# Access Compliance Report

## Public Rights-of-Way

### (Curb Ramps)

Intersection ID: 45169	Main Street: HAZELVIEW_DR	Cross Street: LINDEN_TREE_LN	Location: SW
ADA ID: C2B4F4249AD5	Ramp Type: PerpDiag	Initial Pass/Fail: Fail	Overall Compliance: No
		Severity Score: 8.75

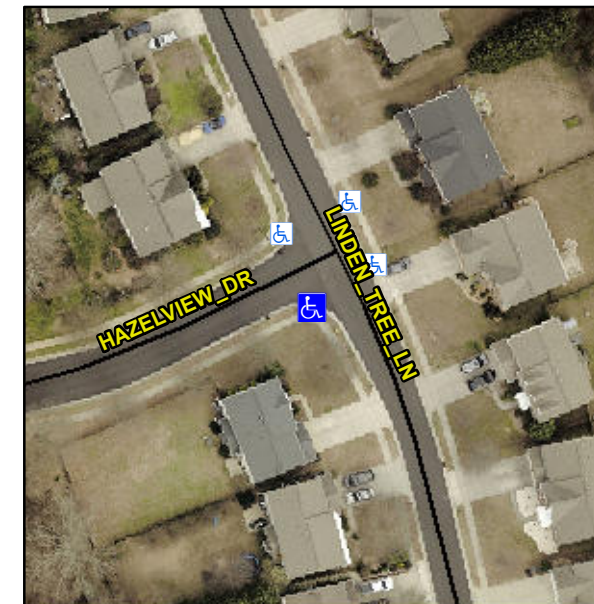
**Not Found, R304.5.1**

Compliance	Description	Data	Compliance	Description	Data
N/A	Ramp Length (in)	41.0	Yes	Ramp Slope (%)	6.2
No	Ramp Width (in)	44.0	Yes	Ramp XSlope (%)	1.6
N/A	Flare Type LT	N/A	N/A	Flare Type RT	N/A
N/A	Flare Slope LT (%)	N/A	N/A	Flare Slope RT (%)	N/A
N/A	Flare Traversable LT?	N/A	N/A	Flare Traversable RT?	N/A
N/A	Landing Length (in)	N/A	N/A	DWS Provided?	N/A
N/A	Landing Width (in)	N/A	N/A	DWS Contrast?	N/A
N/A	Landing Slope (%)	N/A	N/A	DWS Length (in)	N/A
N/A	Landing X Slope (%)	N/A	N/A	DWS Full Width?	N/A
N/A	Landing Curb? (Y/N)	N/A	N/A	DWS Offset (in)	N/A
N/A	Shared Landing?	N/A			
N/A	Gutter Ponding?	N/A	N/A	Gutter Slope (%)	N/A
N/A	Gutter Lip Ht (in)	N/A	N/A	Gutter X Slope (%)	N/A
N/A	Painted X Walk1?	No	N/A	Painted X Walk2?	No
	X Walk 1 Direction	To E		X Walk 2 Direction	To NW
N/A	X Walk 1 Width (in)	N/A	N/A	X Walk 2 Width (in)	N/A
	X Walk 1 Slope (%)	3.5		X Walk 2 Slope (%)	2.5
	X Walk 1 X Slope (%)	0.2		X Walk 2 X Slope (%)	2.4

**Remove & Replace Curb Ramp With Two New Directional Ramps or Equivalent.**
